Comments #531-536. Supporting material clarifying comments against PCS Transmit bit ordering diagrams.

IEEE 802.3bs Task Force, Fort Worth, Sept 12-16, 2016

PCS Transmit bit ordering diagrams

Figure 119-11—400GBASE-R Transmit bit ordering

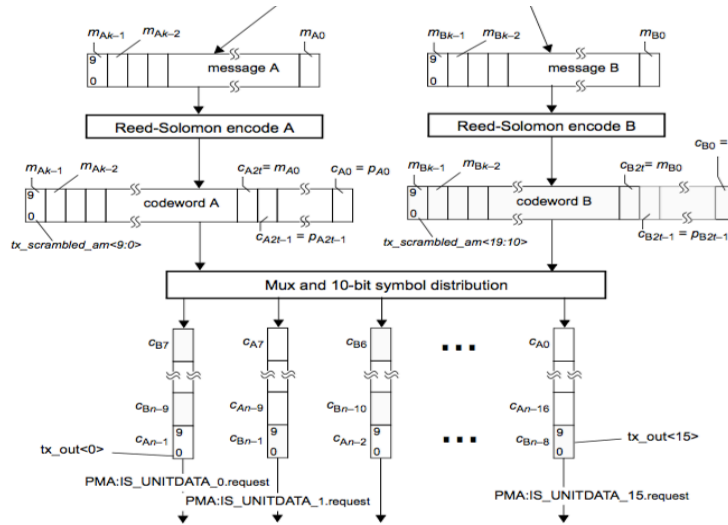
Proposed Changes
